Anglia Square, Norwich
Arboricultural Impact Assessment
Addendum

Dated July 2022

**ARBORICULTURAL
IMPACT
ASSESSMENT
(ADDENDUM)**

Anglia Square, Norwich

UPDATED TREE RETENTION/REMOVAL AND PROTECTION PLAN

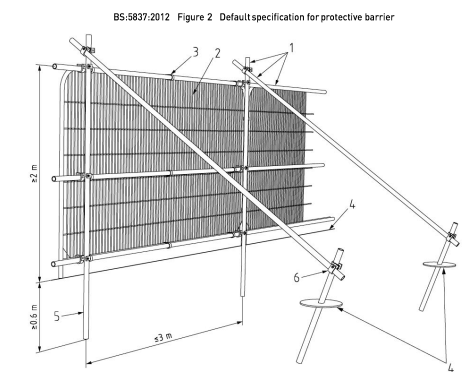
Comments Received	Project Team Response
<p>The tree group containing T14 and T15 (trees to be removed) is a significant landscape feature in the area, and, as a group, possesses high amenity value. Removal of T14 and T15 will diminish this value (but not to an unacceptable level).</p> <p>However, it is extremely important to secure the future of this group, and the continuing contribution it makes, therefore, I would like to see replacement planting at the eastern end of the group utilizing species that will attain the same stature as the retained trees (eg. planting 3-4 heavy standard planes or limes).</p>	<p>The assessment made on impact of proposed loss of T14 and T15 is agreed.</p> <p>The Landscape Masterplan proposes extensive new tree planting. In the area to the east of T16 new tree planting is proposed.</p> <p>Where a new tree within the wider group of trees can be successfully established (between T9 and T22) one is proposed. Further east (to the east of T10) 4No. new trees are proposed on the frontage with St Crispin's Road. This planting utilises all the available planting space in this area for new trees.</p>

Comments Received	Project Team Response
<p>Once T14 and T15 are removed, the new highway access/egress will be next to T16. How close will this be to the tree? Will it be within the root protection area? Details on distances/dimensions, and a tree protection plan with method statements would be useful in this regard.</p>	<p>The new access is proposed outside of the default RPA of T16. A small section of existing carriageway within RPA will be removed and replaced.</p> <p>As proposed within the submitted AIA report, and due to the proximity of the works to the edge the RPA, a full and detailed AMS for the new access will be prepared.</p> <p>In line with the approach set out in BS5837:2012 this detail can be secured by planning condition and once the final construction detail drawings have been prepared and received technical approval.</p>
<p>Due to the number of trees proposed as mitigation, removal of G1, T2, T3 and T6 is acceptable.</p>	<p>Noted. There will be no reduction in the number of news trees proposed to be planted.</p>

<p>In terms of replacement planting throughout the site, restrictions may occur due to the presence of underground services. Details around number of trees/planting pit design/exact locations would need to be confirmed.</p>	<p>The presence of services and how they interact with new tree pits is an important consideration.</p> <p>Tree pit locations have been designed to avoid below ground constraints but on a development of this scale the approach would be to realign and rationalise any services where they may conflict with tree pit locations. Where this is not possible it may be necessary to reposition the tree pit or construct the tree pit accordingly to accommodate the presence of below ground services.</p> <p>The final construction details for the tree its will need to be prepared and gain technical approval. These details can be secured by planning condition.</p>
<p>Responsibility for watering/aftercare of new trees would also need to be confirmed, as well as long term responsibilities in terms of costs/future maintenance.</p>	<p>All new tree planting will be watered and maintained by the relevant contractor throughout the maintenance/defects liability period and inline with the requirements of any associated planning condition as may be imposed. Ultimately, the maintenance of all new tree planting will be funded and carried out by a Management Company and again inline with the requirement of any planning condition and approved documents (e.g a detailed landscape management plan).</p>

- 4.1. The proposed tree loss and associated mitigation has been agreed.
- 4.2. The new highway access is located outside of the RPAs of retained trees and through utilising a detailed AMS, these trees can be adequately protected during construction activities to sustain their health and longevity.

- 4.3. An Arboricultural Method Statement and finalised Tree Protection Plan will need to be produced. Where the feasibility of a scheme has been agreed upon by the Local Planning Authority, this detail can be agreed and submitted later as part of a reserved matters application or pre-commencement planning condition (by agreement with the applicant).
